UTILITY ENCLOSURES

TREASURE ISLAND AND YERBA BUENA ISLAND

PHASE 3 - DESIGN REVIEW

SAN FRANCISCO ARTS COMMISSION

METAL PANEL MATERIAL

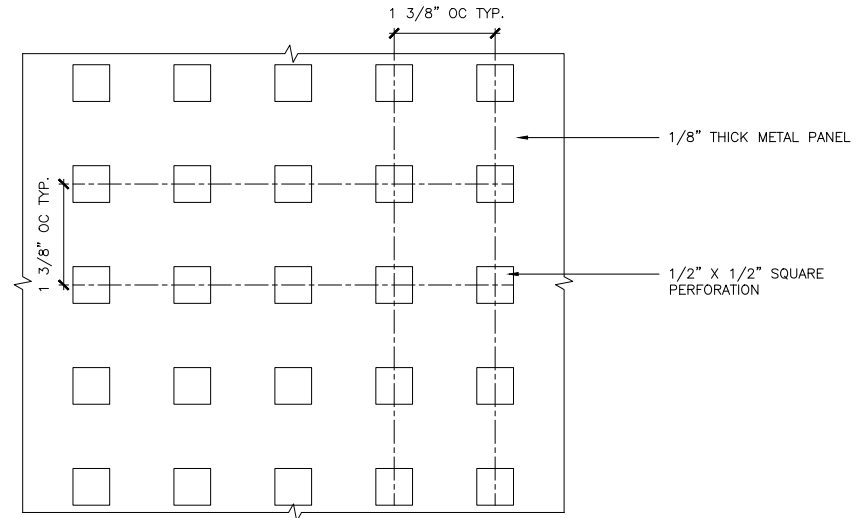
METAL PANEL MATERIAL CHANGE - PERFORATION SIZE AND SPACING CHANGE

PREVIOUS MATERIAL AND PERFORATION SIZE :
PAINTED ALUMINUM
1/4" PERFORATIONS AT 1/2" OC
25% TRANSPARENCY

CURRENT MATERIAL AND PERFORATION SIZE :
PAINTED STAINLESS STEEL
1/2" PERFORATIONS AT 1 3/8" OC
13% TRANSPARENCY

4TH STREET PUMP STATION CULTURAL PARK

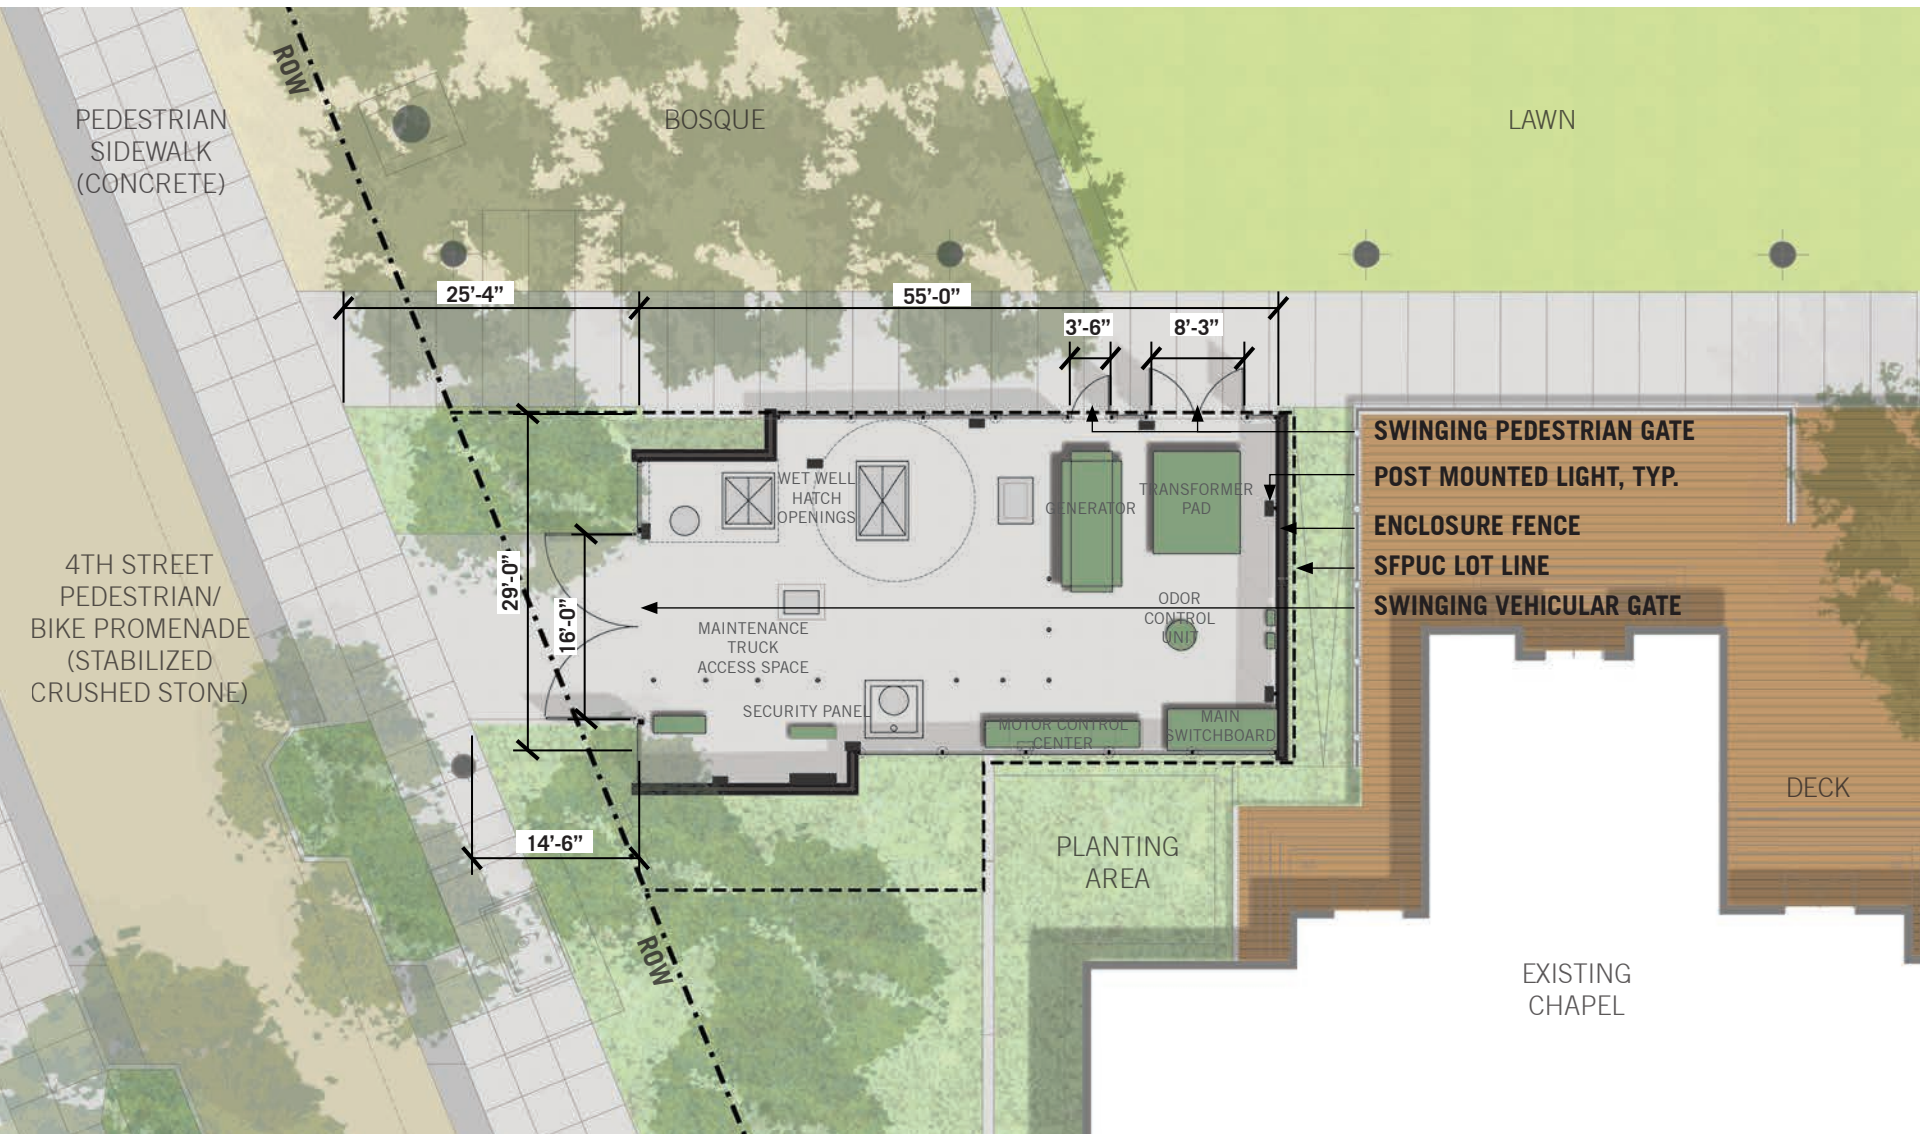
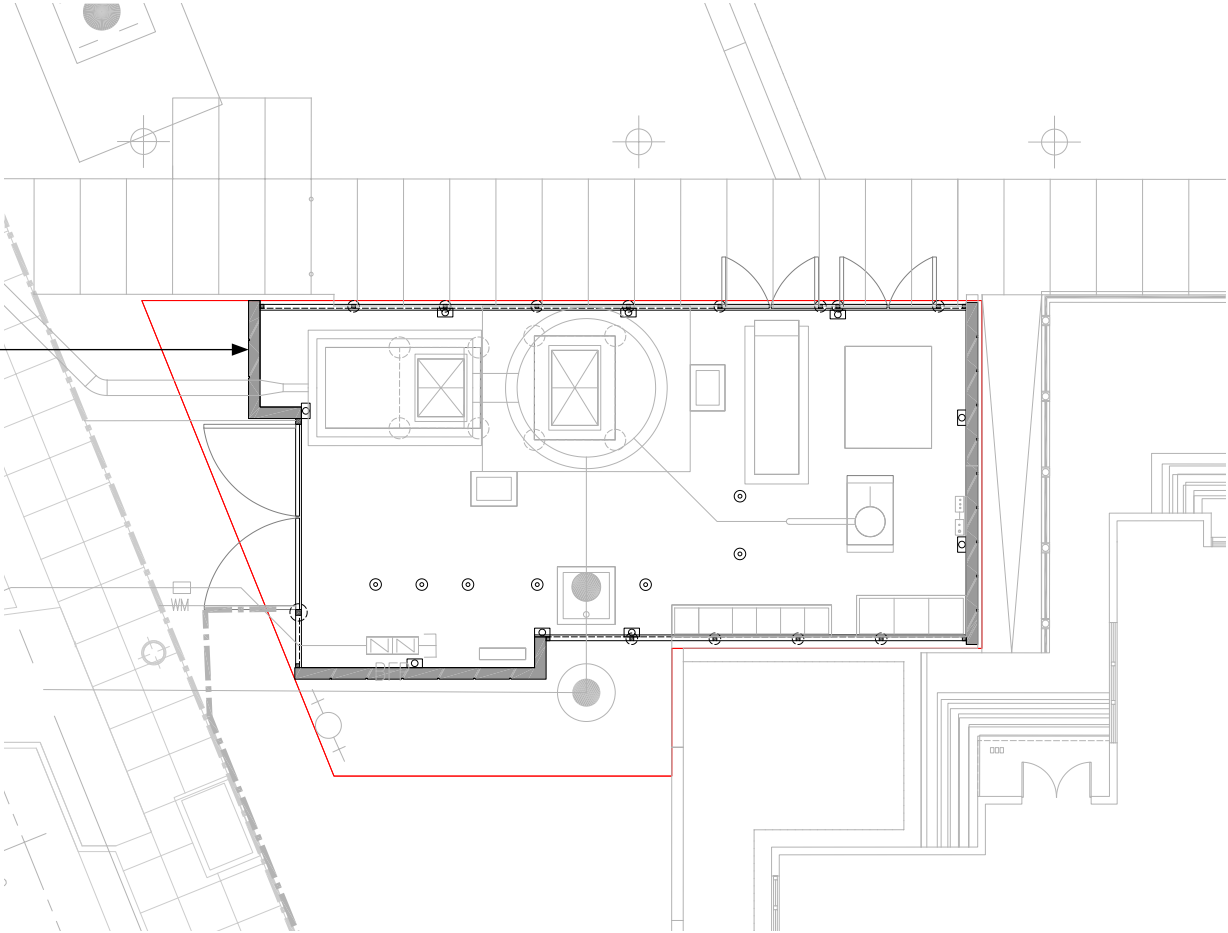
MINOR CHANGE TO ENCLOSURE LAYOUT

PREVIOUS PROPOSED PLAN

CURRENT PROPOSED PLAN

LAYOUT ADJUSTED AT
NORTHEAST CORNER
TO ACCOMODATE
VAULT CLEARANCE
REQUIREMENTS

4TH STREET PUMP STATION CULTURAL PARK

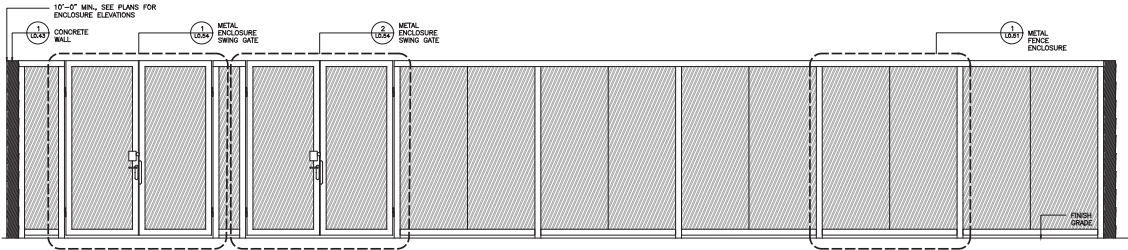
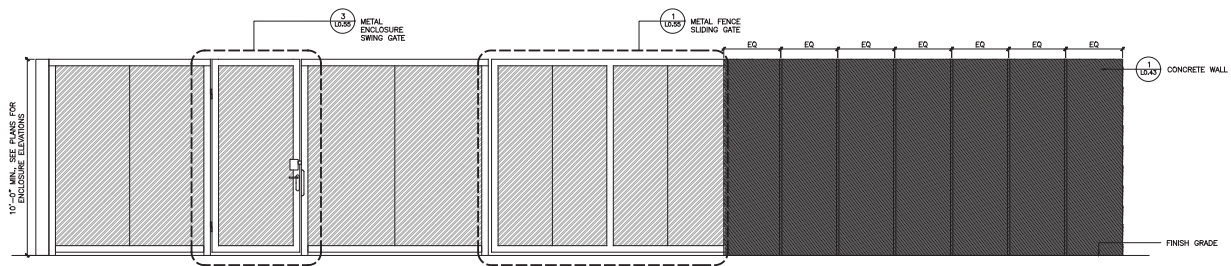
PHASE 2 CONTIGENCY - STUDY VERTICAL SPACING OF POSTS TO BE MORE EQUAL

PREVIOUS NORTH ELEVATION

CURRENT NORTH ELEVATION
